**Re: Aloft Hotel Sunport**  
**1501 Aircraft Ave. SE**  
**Traffic Circulation Layout**  
Engineer's Stamp 7/18/2025 (M15D057)

The TCL submittal received 6/30/2025 is approved for Building Permit by Transportation. A copy of the stamped and signed plan will be needed for each of the building permit plans. Please keep the original to be used for certification of the site for final C.O. for Transportation.

ENGINEER'S SEAL  RONALD R. BOHANNAN P.E. #7868	ALOFT HOTEL ALBUQUERQUE, NM TRAFFIC CIRCULATION LAYOUT   TIERRA WEST, LLC 5571 MIDWAY PARK PL NE ALBUQUERQUE, NEW MEXICO 87109 (505) 858-3100 www.tierrawestllc.com	DRAWN BY MR
		DATE 07/18/2025
		SHEET # 18 JOB # 2021133

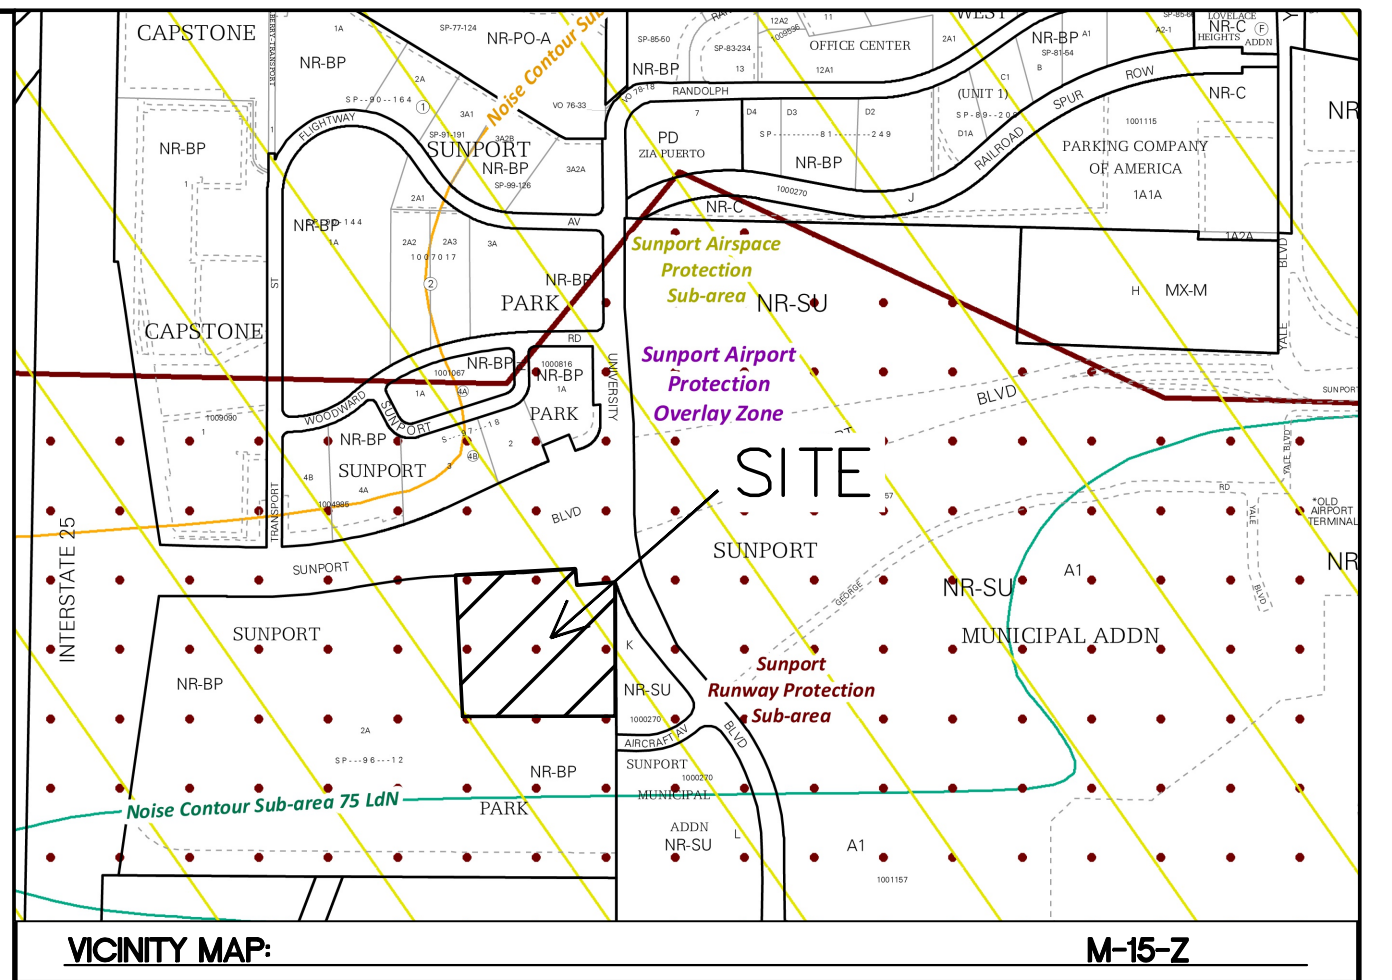
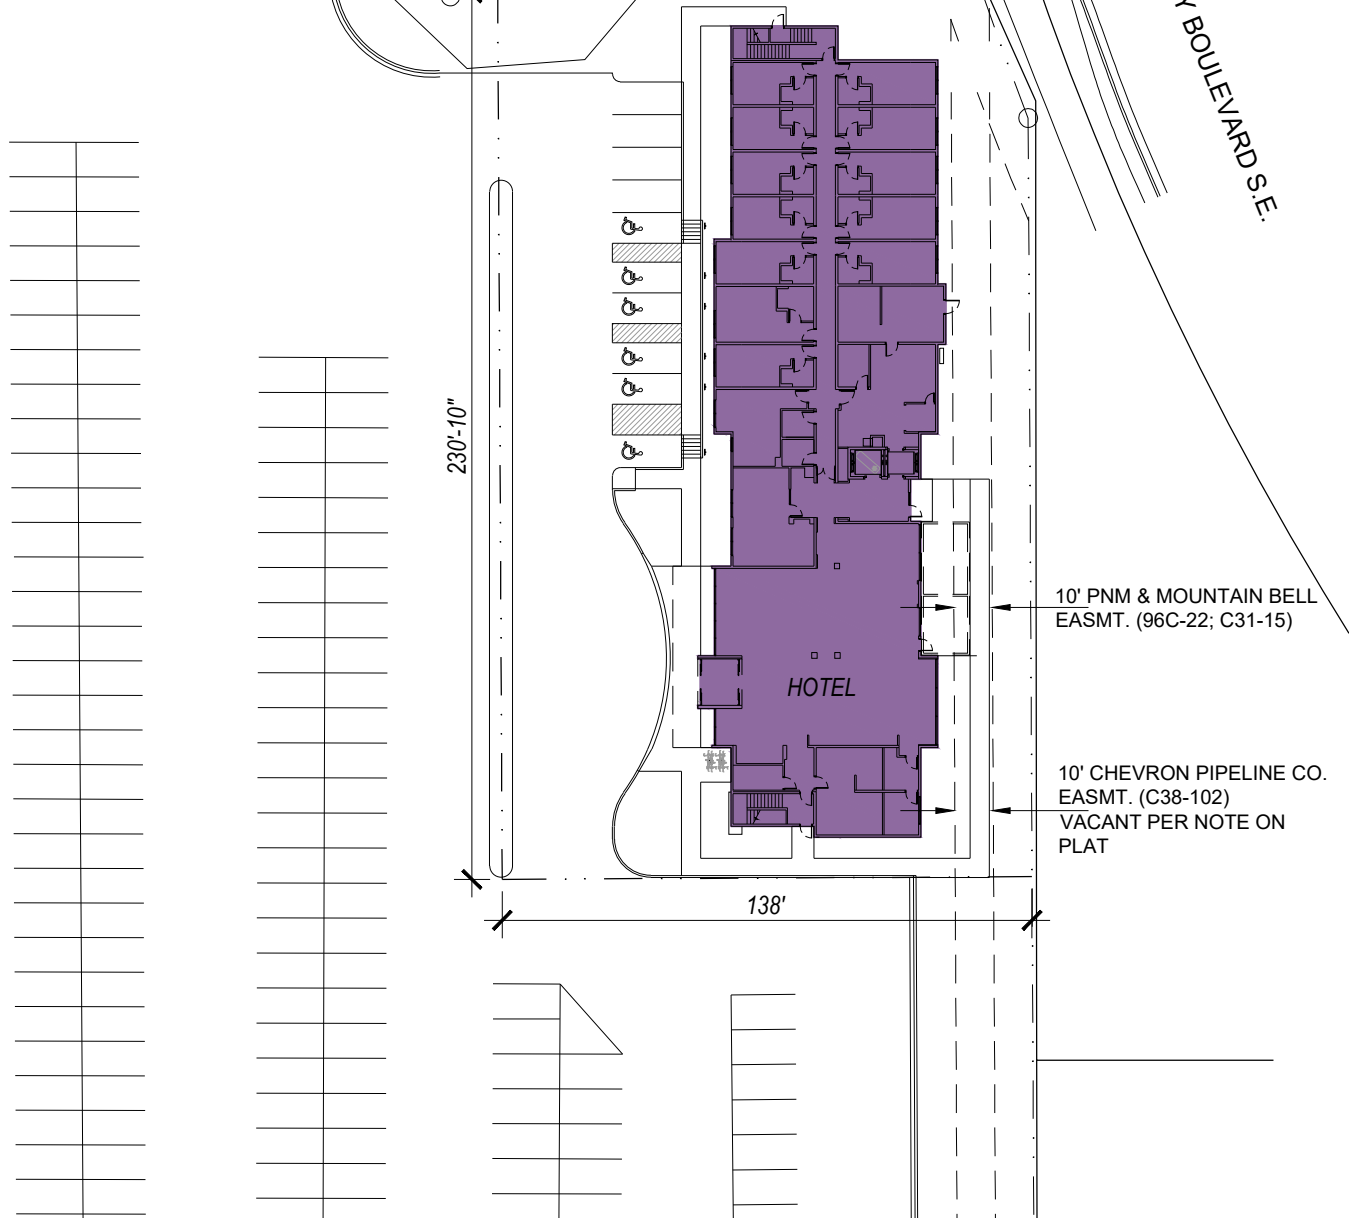
TRAFFIC CIRCULATION  
LAYOUT APPROVED
